**TOWN OF TRUMBULL, WATER POLLUTION CONTROL AUTHORITY**  
**RFP # 6297**  
**TRUMBULL BEARDSLEY PUMP STATION COMPREHENSIVE UPGRADE**  
**ADDENDUM NO. 3**

## PUMP AROUND CONNECTION DETAIL

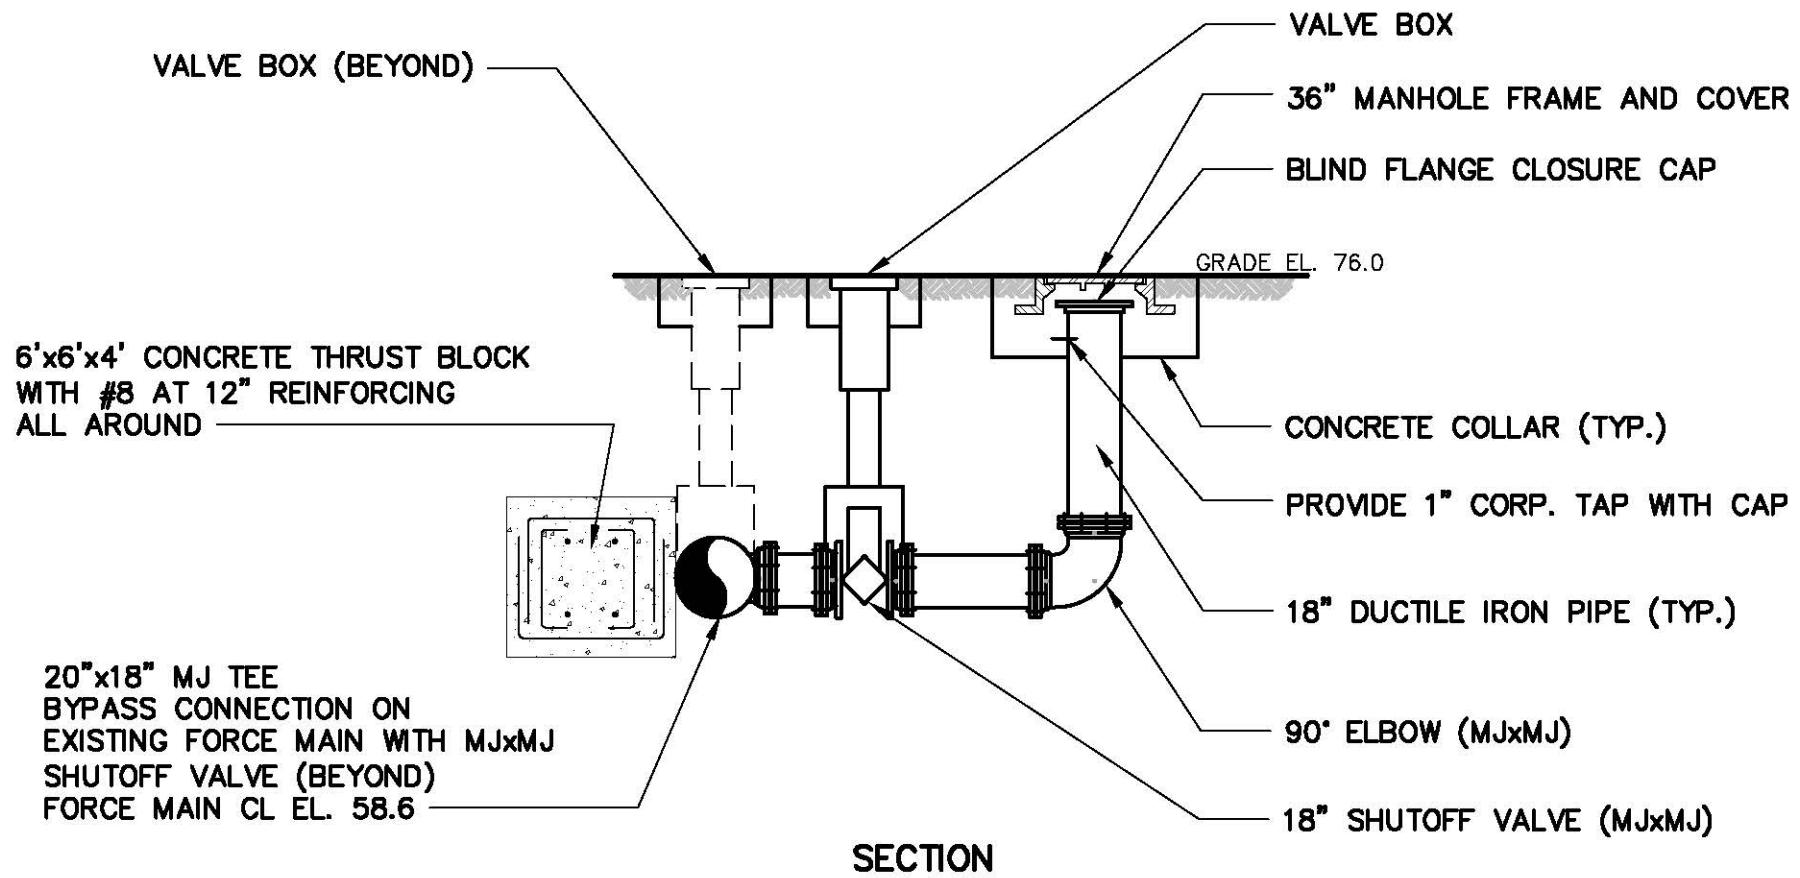
1. Replace “PUMP AROUND CONNECTION DETAIL” with new version included as an Attachment to this Addendum.

2. Question: On drawing C-7, we have the following questions on the pump around connection detail:

- a. Will the tees and elbows require concrete thrust blocks?
- b. What type of end connection is at the end of the 18" pipe?
- c. Is there any support required for the new manhole cover and frame?

Response: Refer to revised Detail provided as an attachment to this Addendum.

1. ALL JOINTS SHALL BE RESTRAINED.
2. PROVIDE RESTRAINED JOINT GLAND (MEGALUG OR EQUAL) FOR ALL MJ JOINTS.
3. ALL NEW 20" AND 18" DUCTILE IRON PIPE SHALL BE CLASS 56.
4. PROVIDE VALVE EXTENSION STEMS FOR OPERATING NUTS ON VALVES.
